RE: 98th Street and Avalon Road Intersection Reconstruction Project
(Project No. 7856.03)
Drainage Analysis

DEPARTMENT OF MUNICIPAL DEVELOPMENT CONSTRUCTION PLANS FOR 98TH STREET AND AVALON ROAD INTERSECTION RECONSTRUCTION COA PROJECT NO. 7856.03

ENGINEERS STAMP & SIGNATURE	APPROVALS	ENGINEER	DATE	**********
60% REVIEW	DRC Chairman			APPROVED FOR CONSTRUCTION
	Transportation			
	Water/Wastewater			
	Hydrology			
	Parks			City Engineer / Date
	Constr. Mngmt.			
	Constr. Coord.			
PRELIMINARY NOT FOR CONSTRUCTION 9/2014	City Project No. 7856.03			Sheet 1 Of 12

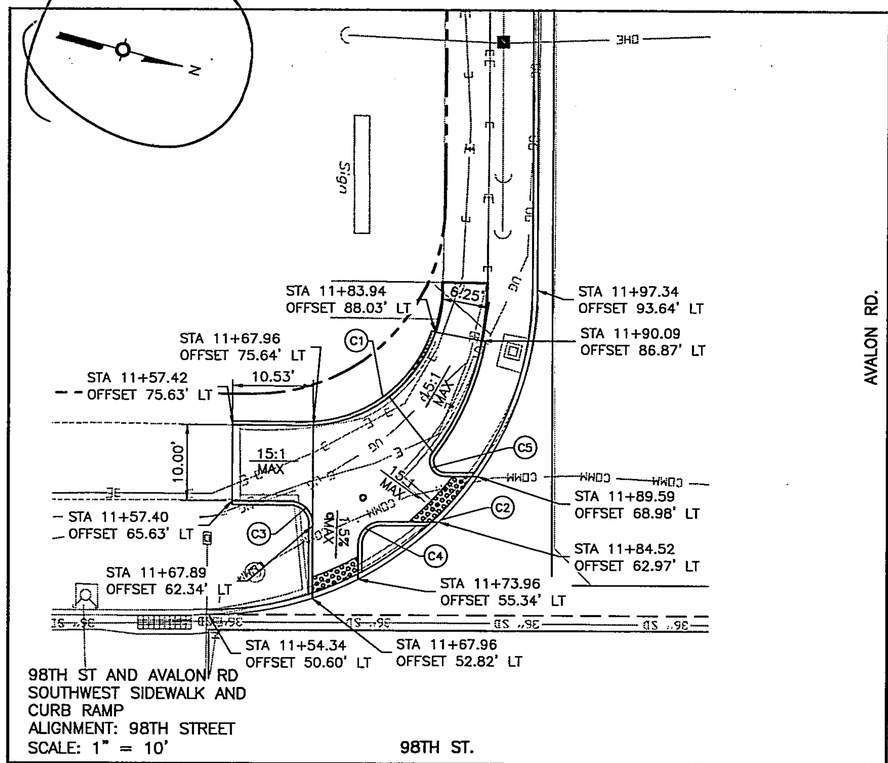
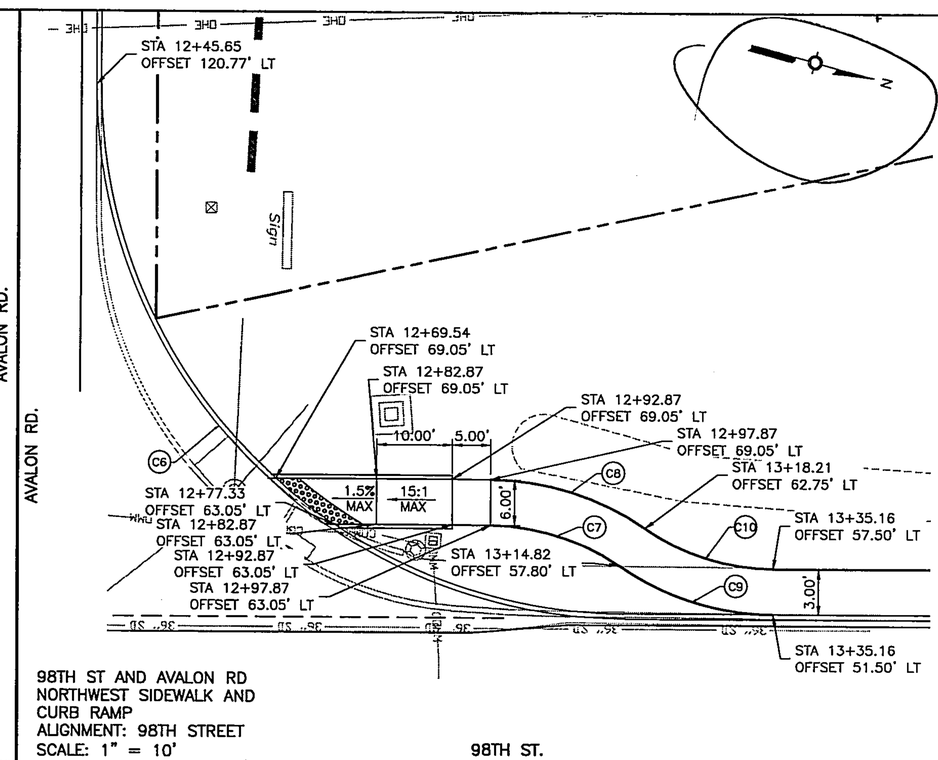
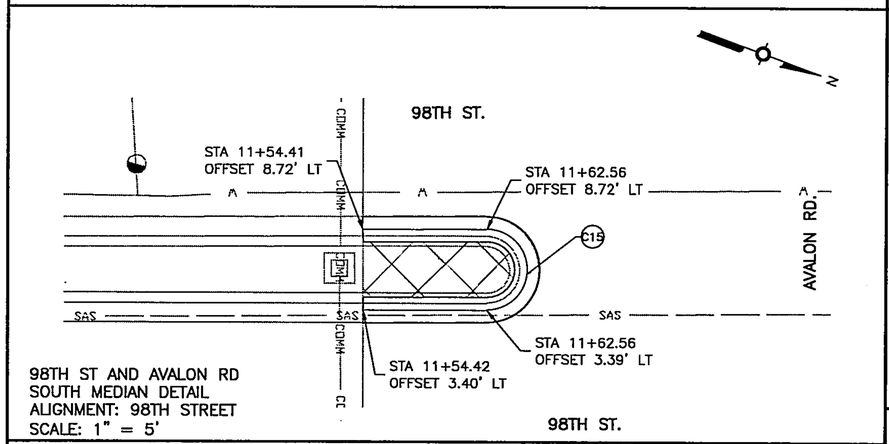
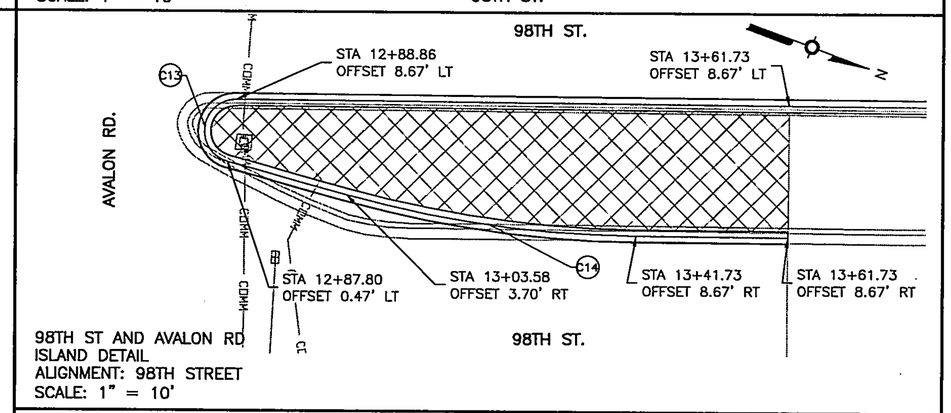
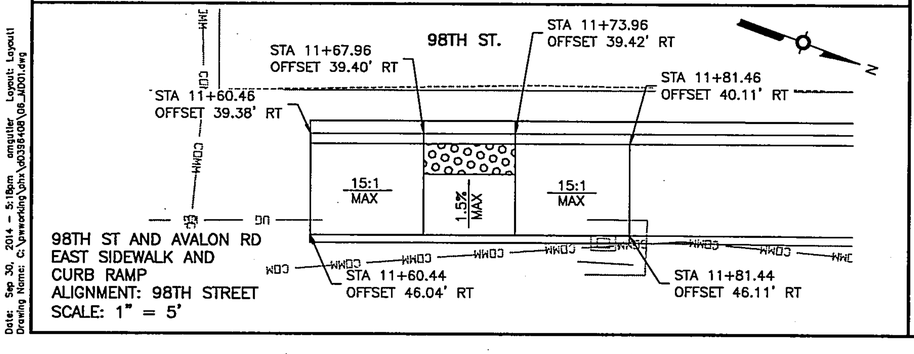
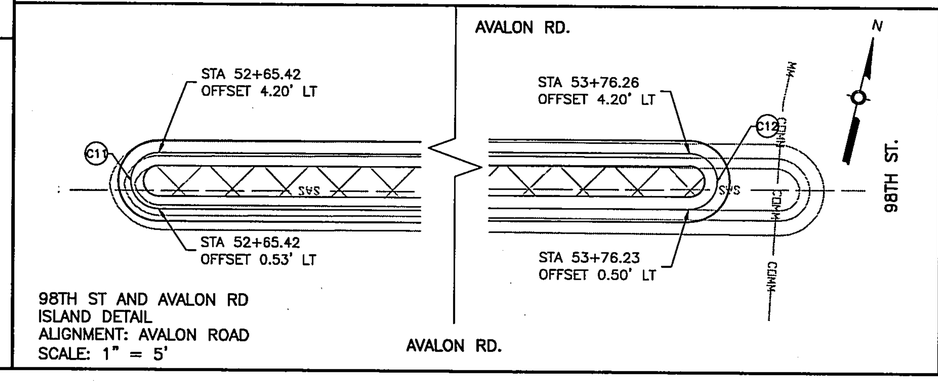
Fix a do
Abbreviations

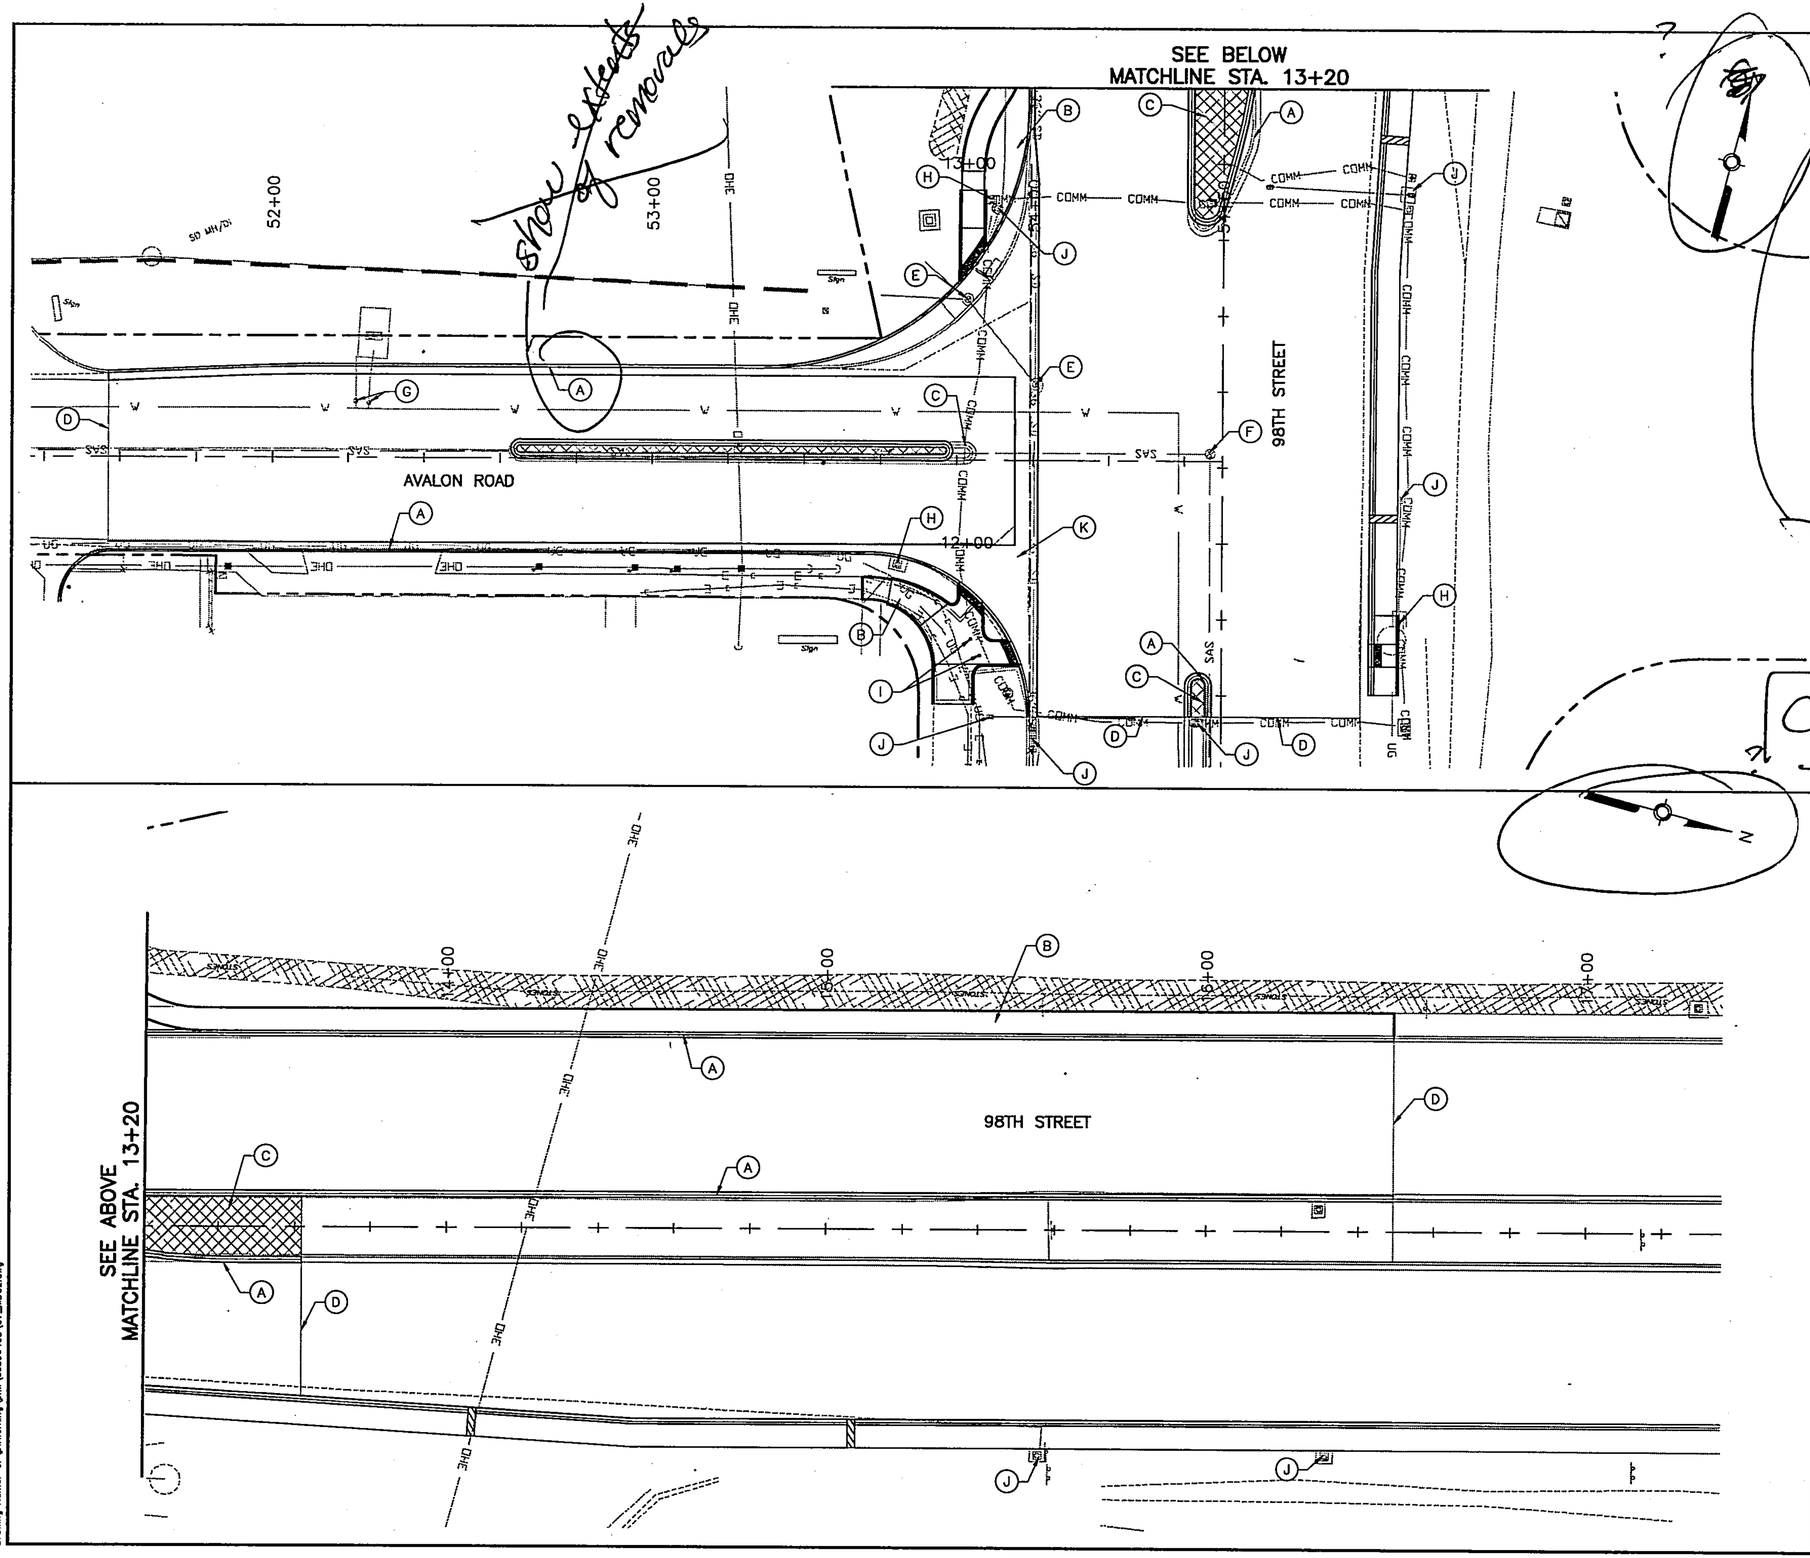
Show extents of removals

Remove to nearest joint.

98TH STREET PLAN AND PROFILE

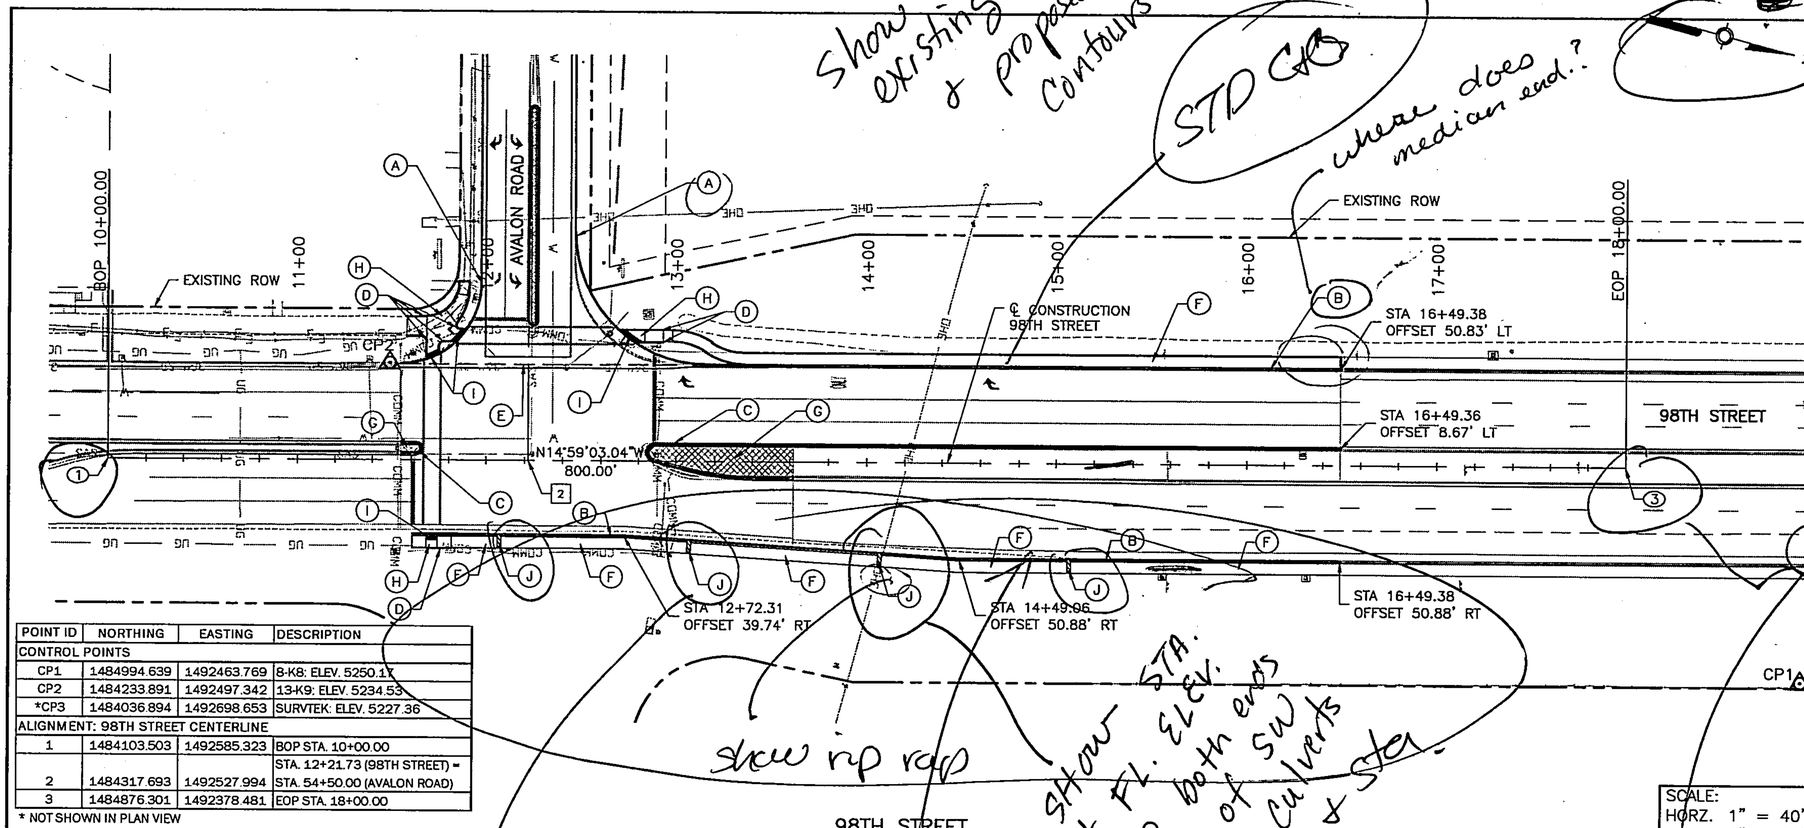
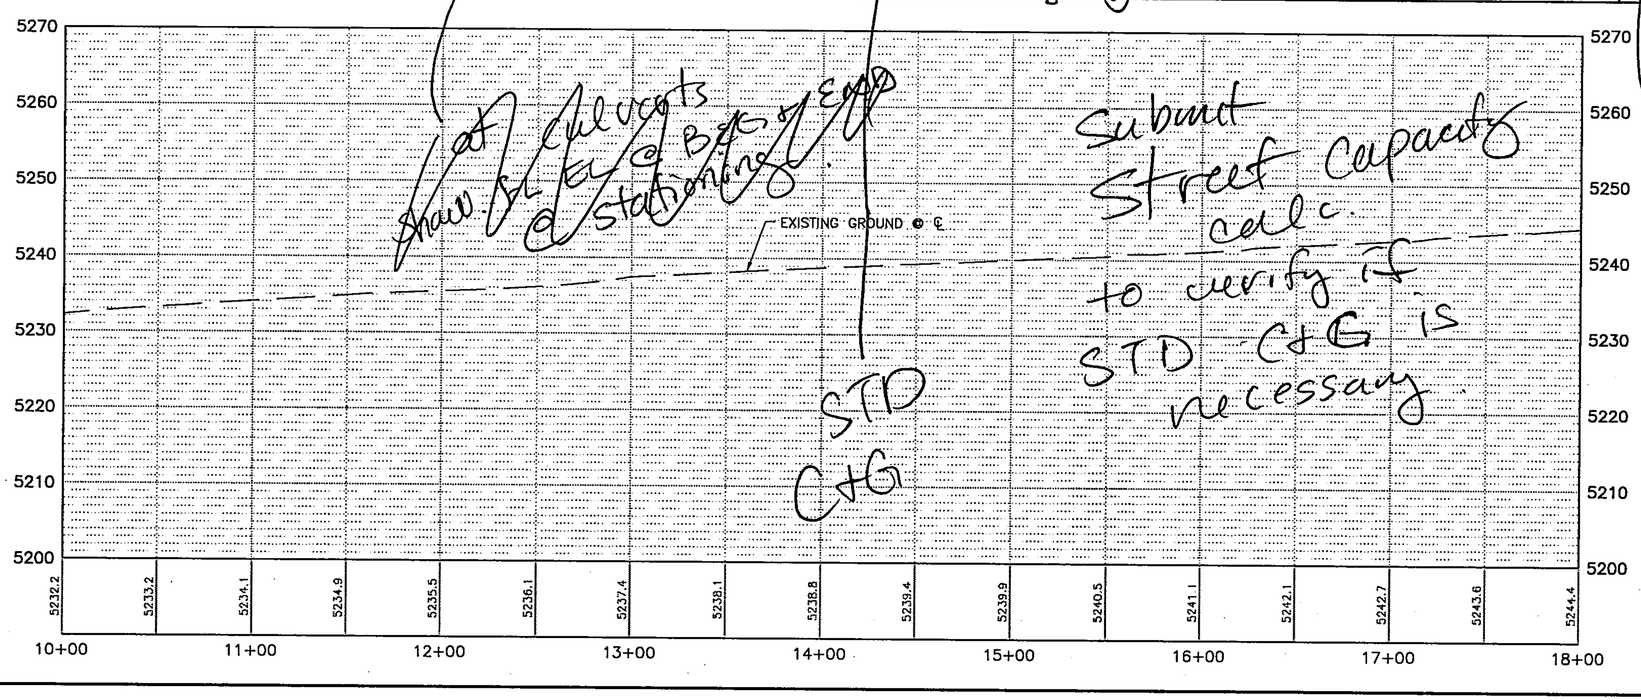
show existing & proposed contours

show rip rap

show STA. FL. ELEV. both ends of SW culverts & @ ⊥ & STA.

show all culverts @ BF & stationing

Submit Street Capacity calc. to verify if STD C&G is necessary

add: "Extend pl. 2' past back of sw"
• Tack weld bolts to plate

Show missing keyed notes

AVALON ROAD PLAN AND PROFILE

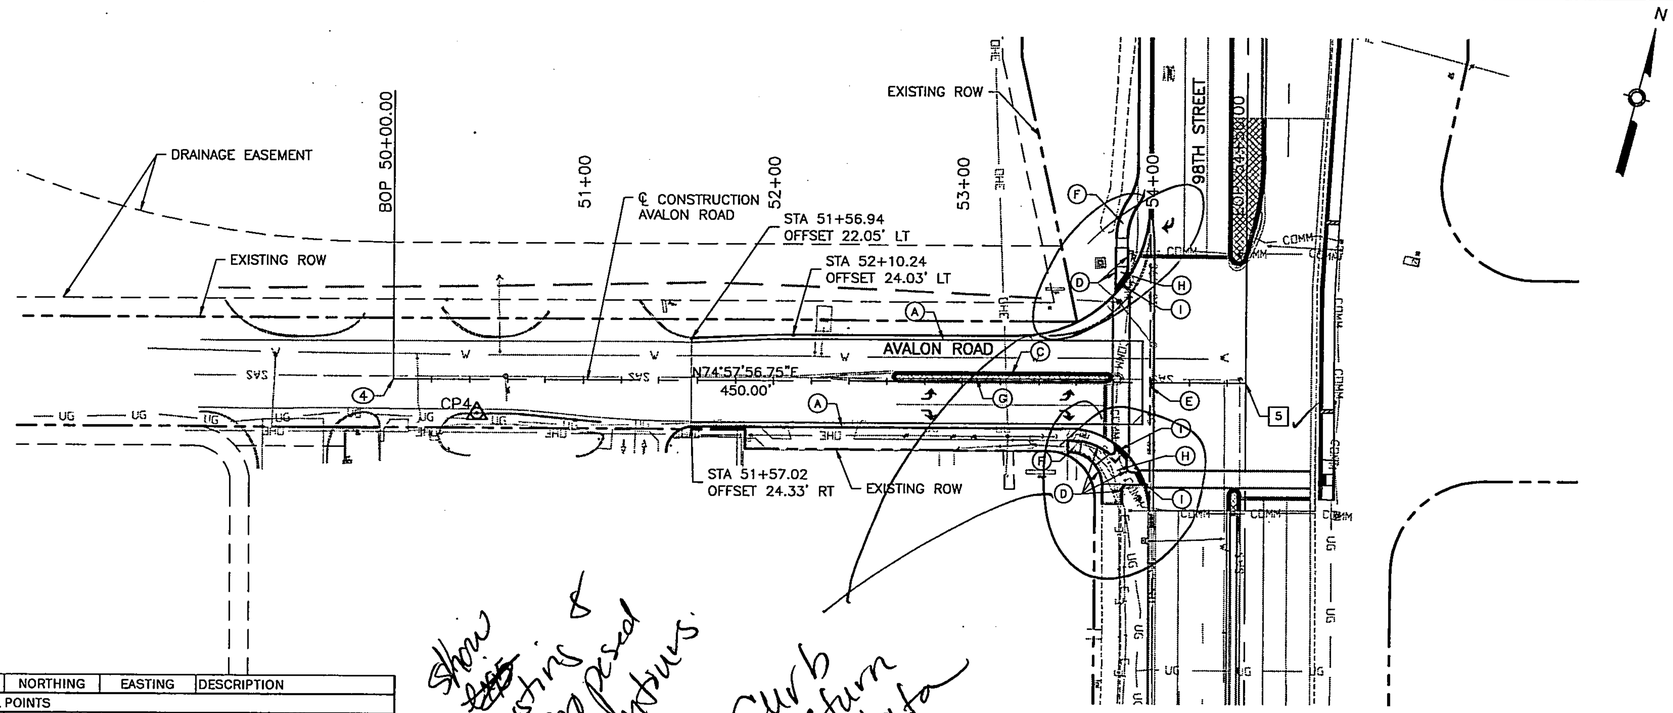
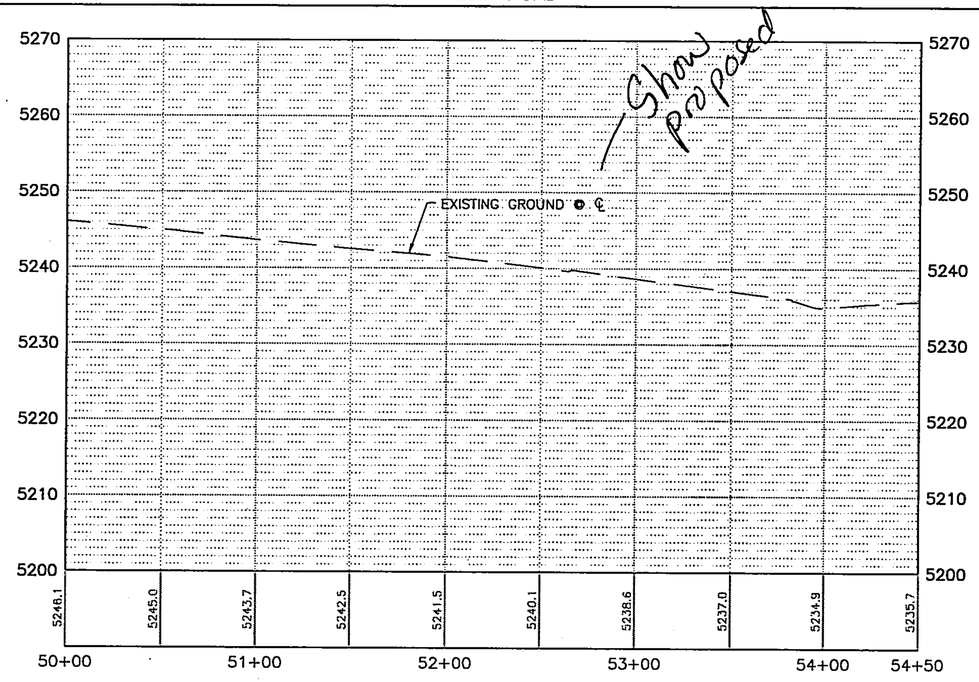
Show ~~all~~ existing & proposed contours.

Curb return data

(H) BUILD CURB RAMP PER DETAIL. ~~SEE MISCELLANEOUS DETAIL SHEET.~~

See previous page for notes to add.
